**Re: Lot 201 - 327 - 335 Burley Road, Horsley Park
 ESR Horsley Logistics Park
 Jalco Manufacturing Facility (SSD-21190804)
 Response to ESR – Letter dated 8 March 2022**

ENCLOSURE 2
NSW DPE Letter dated 8 March 2022

**Jalco Manufacturing Facility (SSD-21190804)
Request for additional information**

DRAWING TITLE
STORMWATER DRAINAGE PLAN SHEET 2
 DRAWING NO.
CRC-CV-C012990.09-C4.2
 ISSUE
5

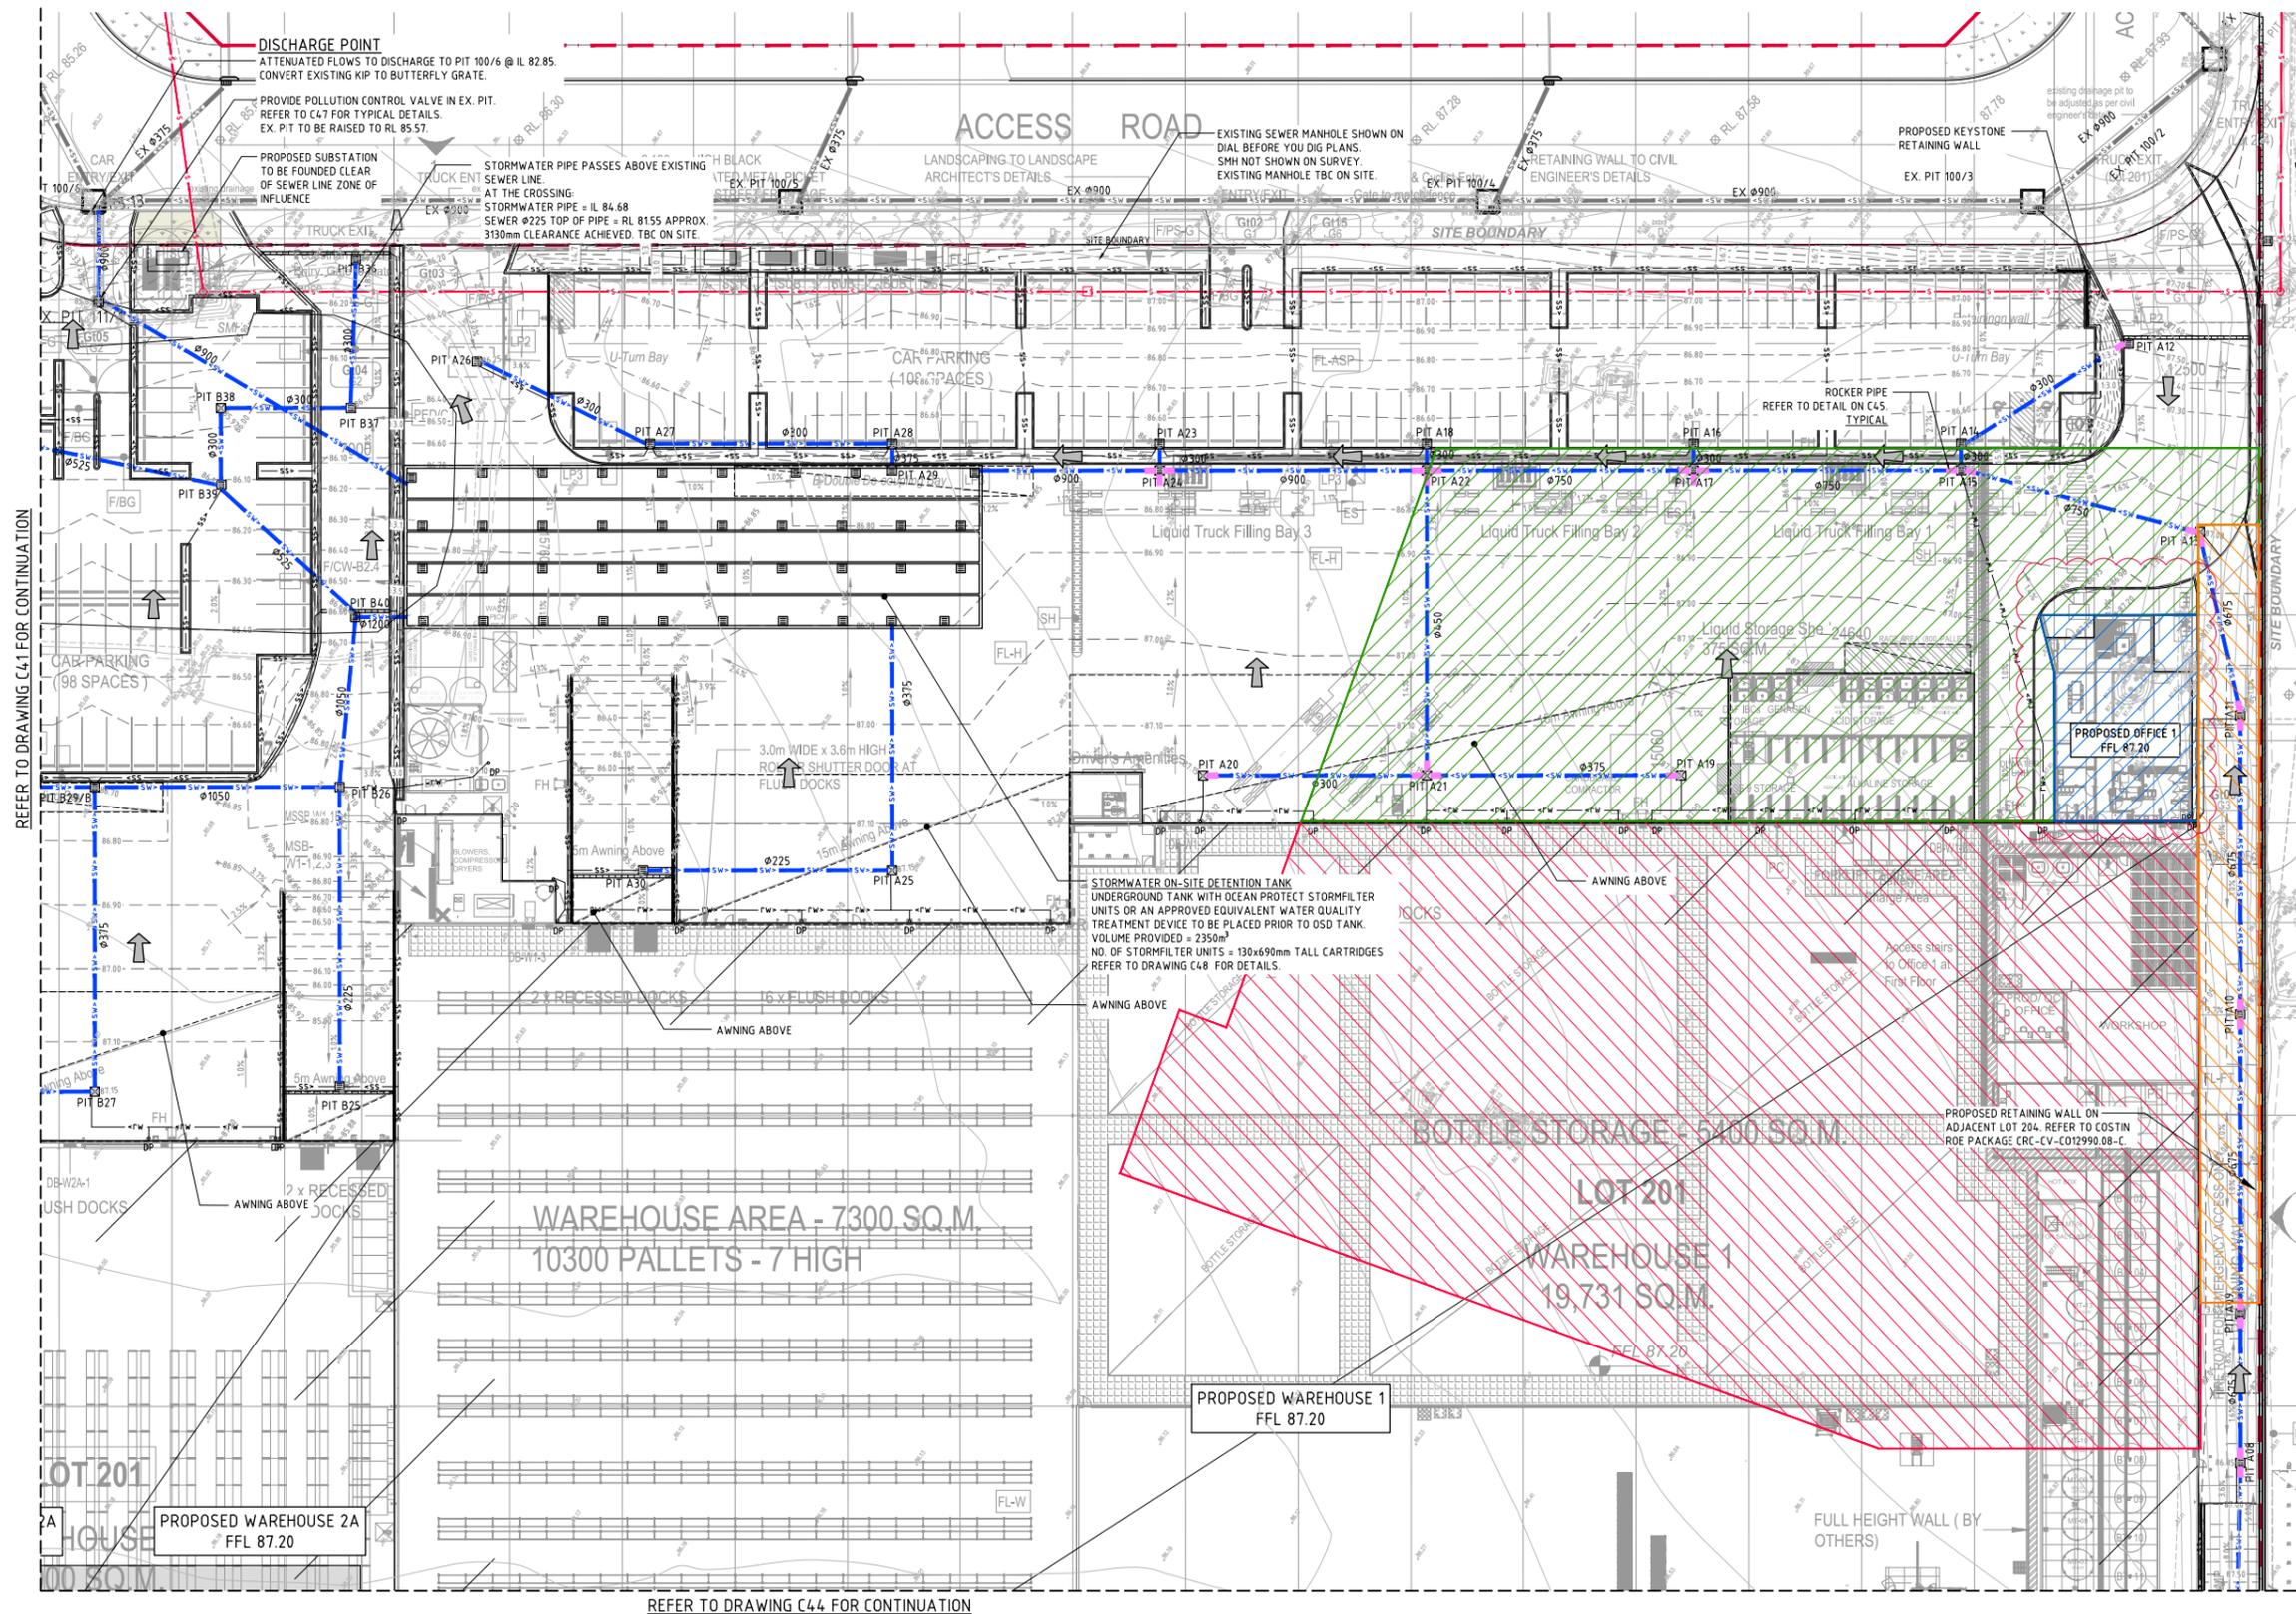
- The RtS, in Appendix A – Dangerous Goods Storage Process Map provides that there would be substantial external handling of DG's including deliveries to external storage areas and moving DG's externally into the production area via forklift when needed. This has the potential to cause contamination of the stormwater system in the case of a spill or fire. The Stormwater Management Plan prepared by Costin Roe and dated 28 May 2021 (Appendix F of the RtS) is for the use of the site as a warehouse and does not include measures to capture and retain contaminated water in the external areas where dangerous goods are stored and handled.

- The external potentially contaminated hardstand areas should be separated from the clean stormwater areas similar to the Smithfield facility as described in the Contaminated Water Retention Plan (Appendix P of the EIS). Please provide details of the contaminated water retention system isolated from the stormwater system.

<i>No.</i>	<i>Item and Response</i>
<i>Water and Wastewater Management</i>	
<i>Item 2</i>	<p><i>The RtS, in Appendix A – Dangerous Goods Storage Process Map provides that there would be substantial external handling of DG’s including deliveries to external storage areas and moving DG’s externally into the production area via forklift when needed. This has the potential to cause contamination of the stormwater system in the case of a spill or fire. The Stormwater Management Plan prepared by Costin Roe and dated 28 May 2021 (Appendix F of the RtS) is for the use of the site as a warehouse and does not include measures to capture and retain contaminated water in the external areas where dangerous goods are stored and handled.</i></p> <p><u>Response:</u></p> <p>We confirm that a pollution control valve has been included as part of the stormwater drainage system for Lot 201. The pollution control valve is required to be installed to EX Pit 111/1 as shown on the enclosed drawing CRC-CV-CO12990.09-C42. The pollution control valve will be installed to the internal private drainage prior to stormwater discharge connection to Johnston Crescent.</p> <p>In case of spill or fire, the pollution control valve is to be closed to prevent contamination of the stormwater system leaving the site. The above is to be implemented in a spill and pollution incident response management plan.</p>
